# Access Compliance Report

## Public Rights-of-Way (Curb Ramps)

Intersection ID: N/A	Main Street: ARROWOOD_RD	Cross Street: MICROSOFT_WY	Location: SE
ADA ID: BC21ADC5AA2A	Ramp Type: Perp	Initial Pass/Fail: Pass	Overall Compliance: No
Codes/Mitigation Info/Possible Solution			Severity Score: 30
			Field Measurements/Component Compliance

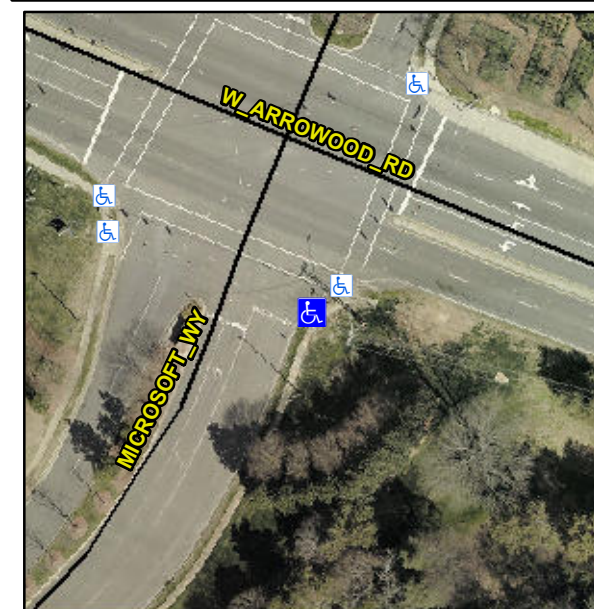
**R304.2.1, R304.2.2-Perp, R304.3.2-  
Para, R305, R302.7, R302.7.2,  
R304.5.4**

**Remove & Replace Entire Ramp.  
Remove & Replace Gutter.**
